September 27th, 2024

Addendum #1

Project Title: Capital Fund Program Improvements for **The Asbury Park Housing Authority**
New Common Area Flooring Work with Wall Base at
Lumley Homes A/B located at 1004 Comstock Street & 1025 Second Avenue
Comstock Court located at 1018 First Avenue
Dr. Robinson Towers located at 1000 ½ Third Avenue
Asbury Park, NJ 07712

Sheet Title
FLOOR PLANS
 Sheet Number
A-101.00

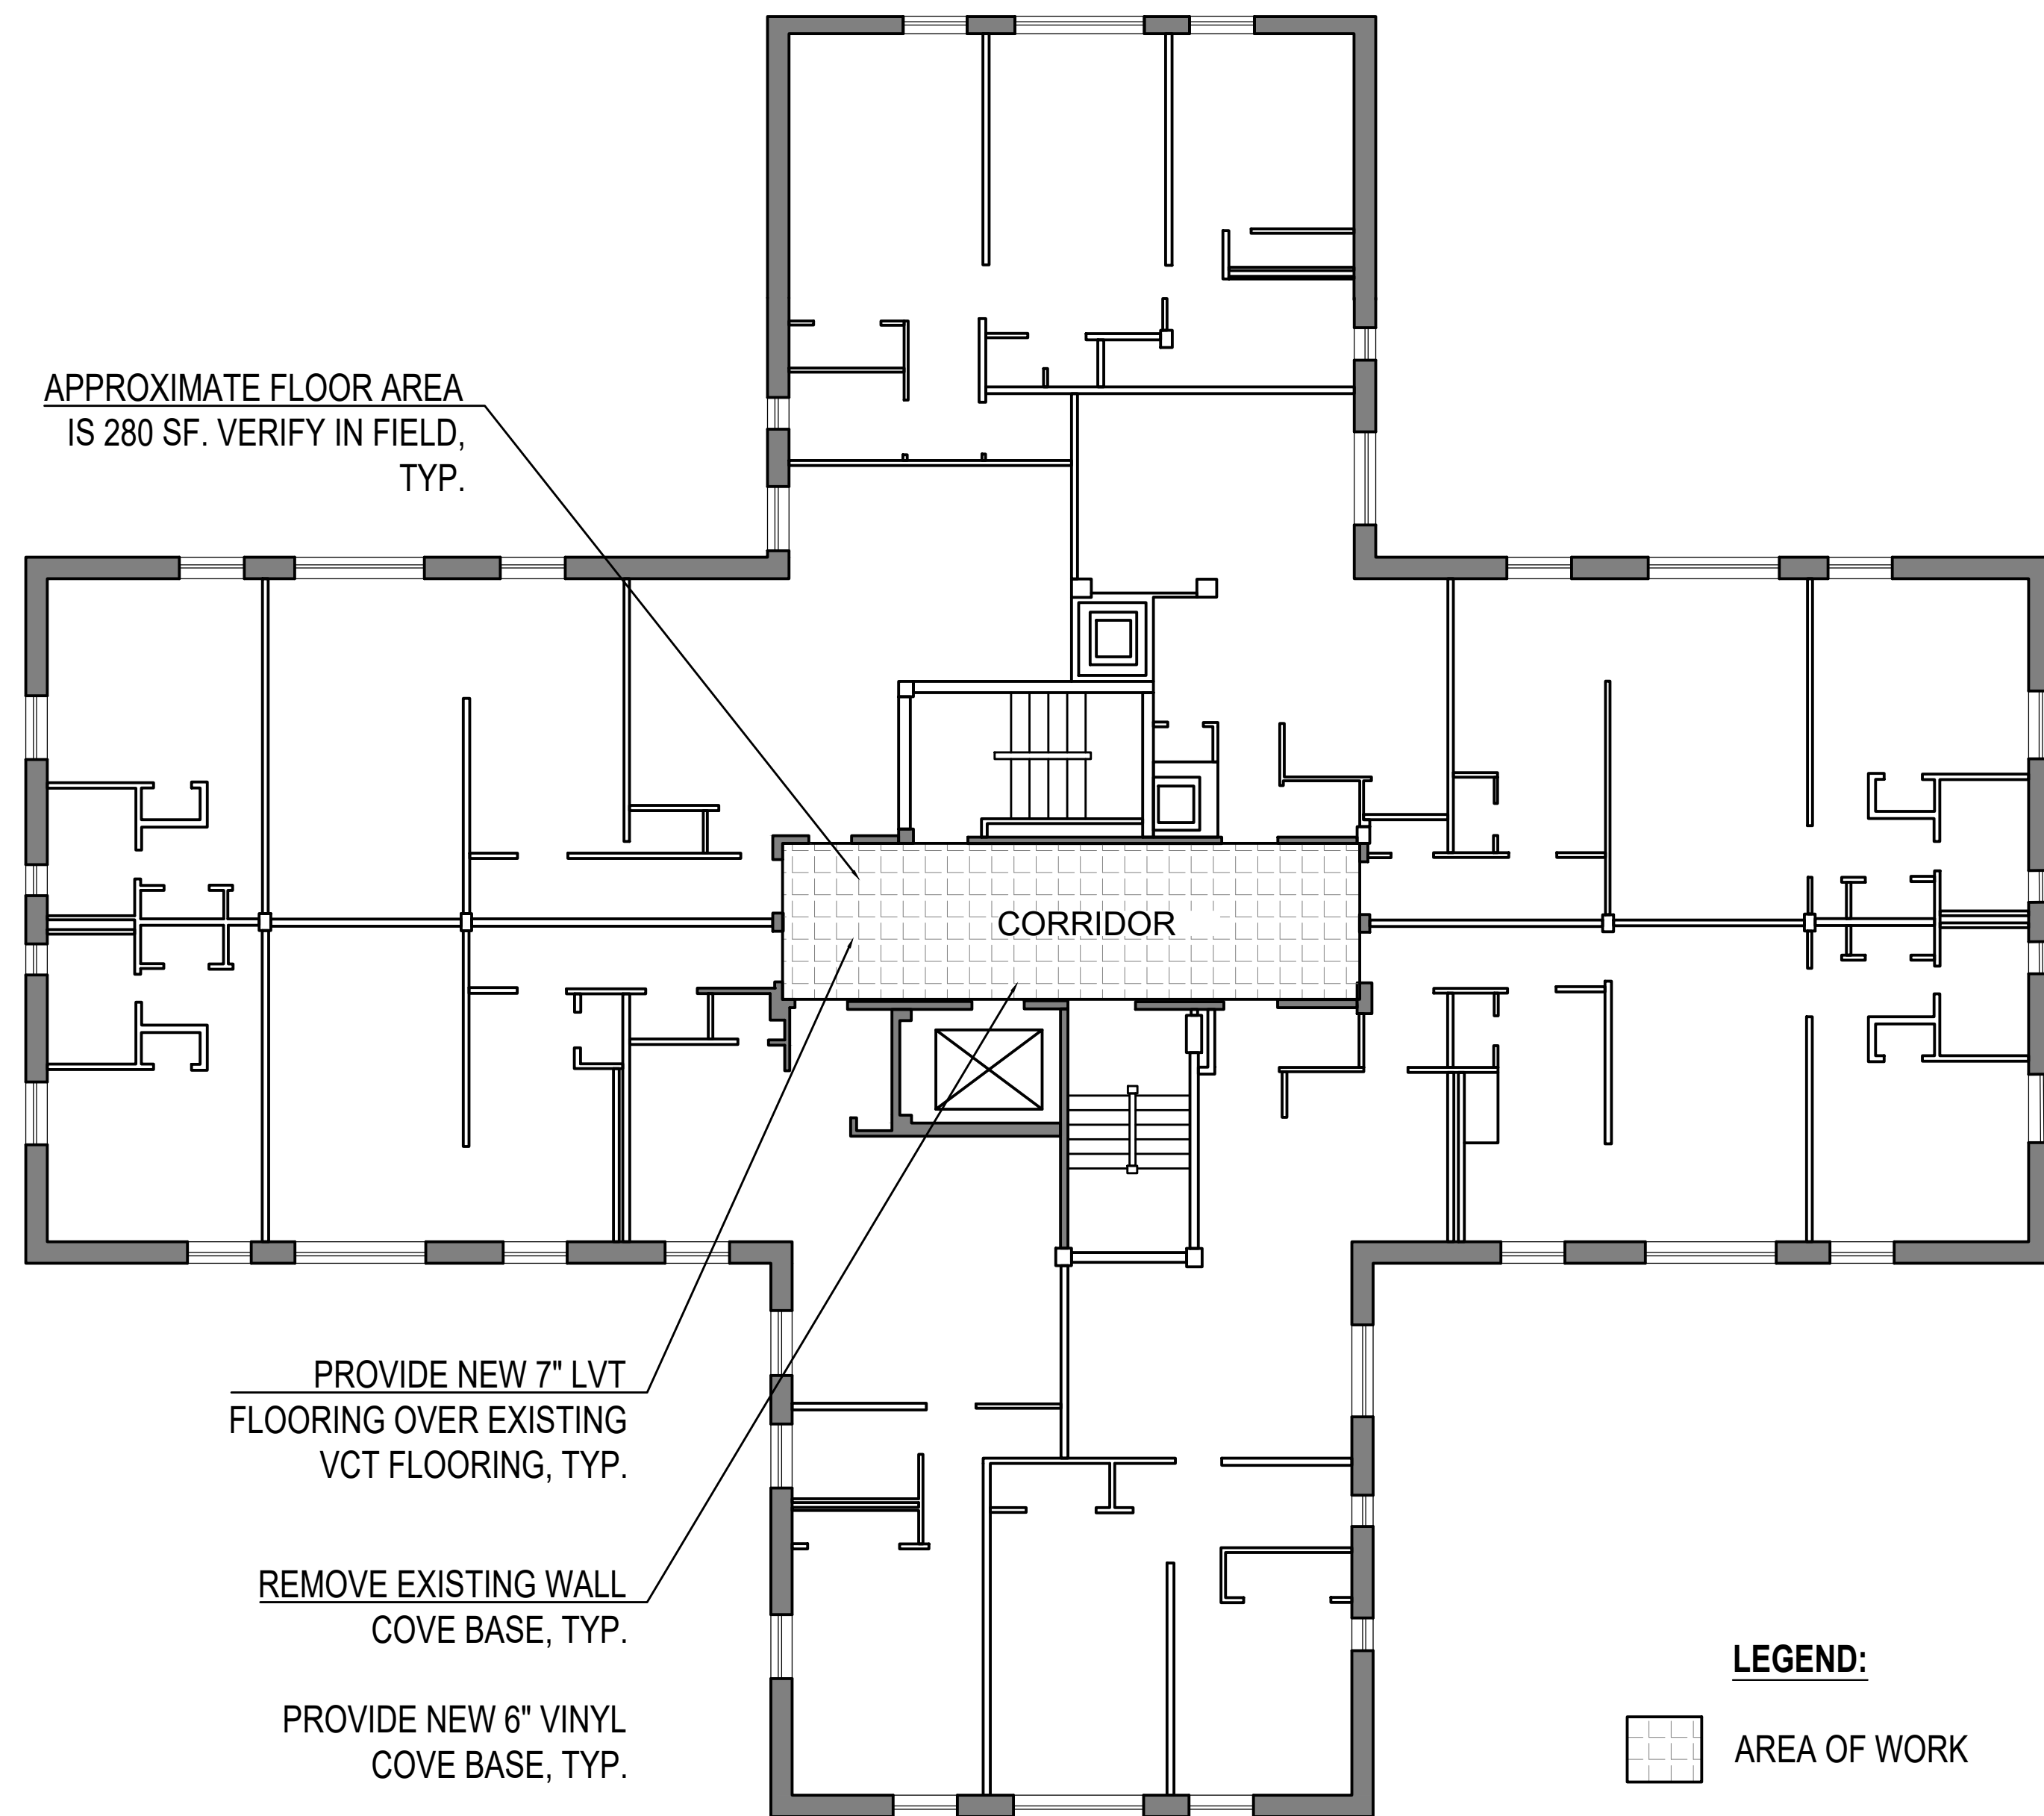
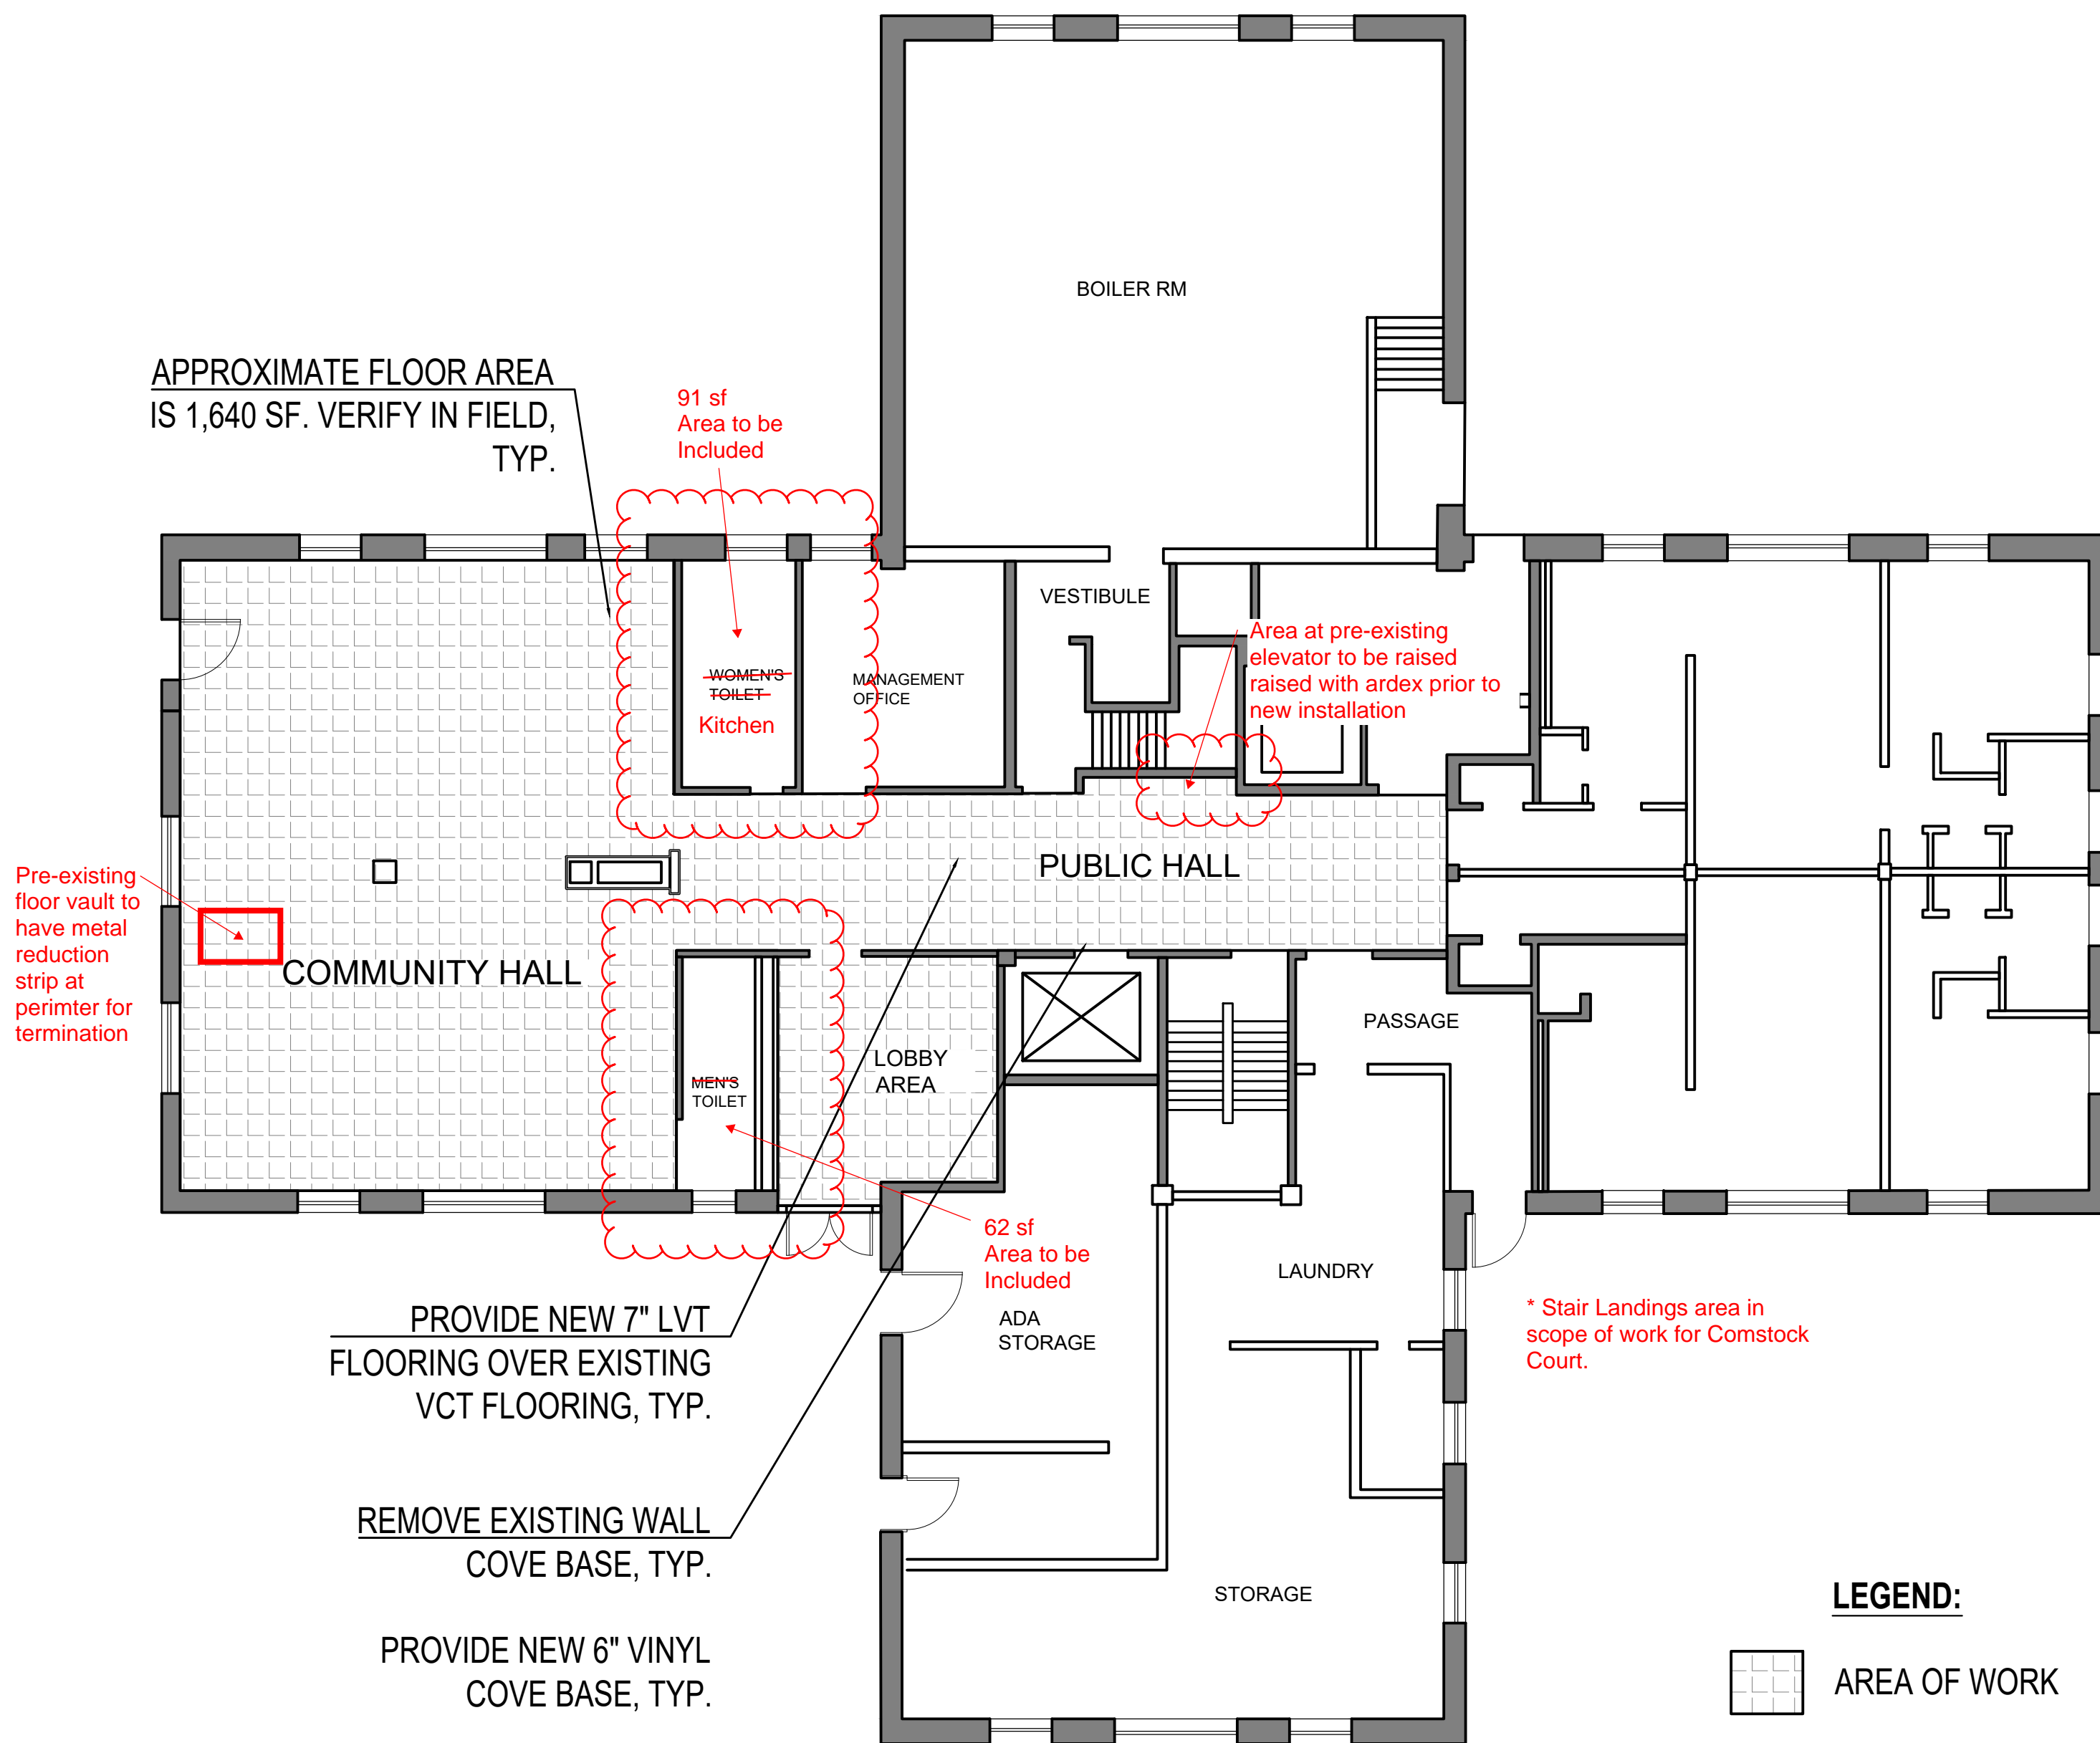
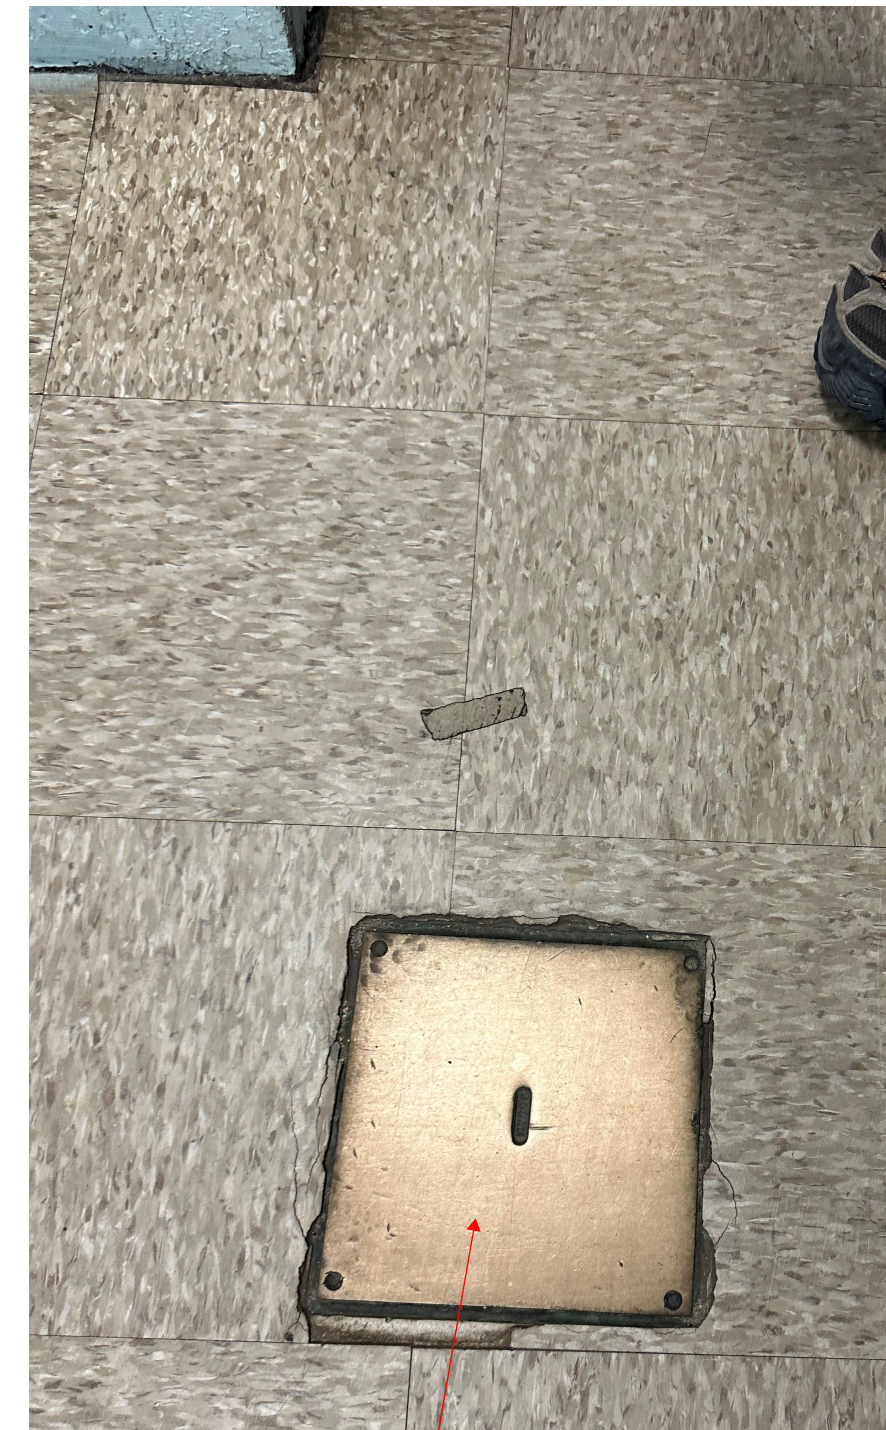
For Comstock Court – Sheet A-101.00 Attached

5. Existing floor area in front of the elevator system is depressed / defecting. This area needs to be leveled with Ardex TL-1000 compound then LVT installed over the new leveled substrate.
6. All Stairwell landings are not in scope of work at this site.
7. Existing kitchen & unisex toilet within the community room are to have new flooring installation.
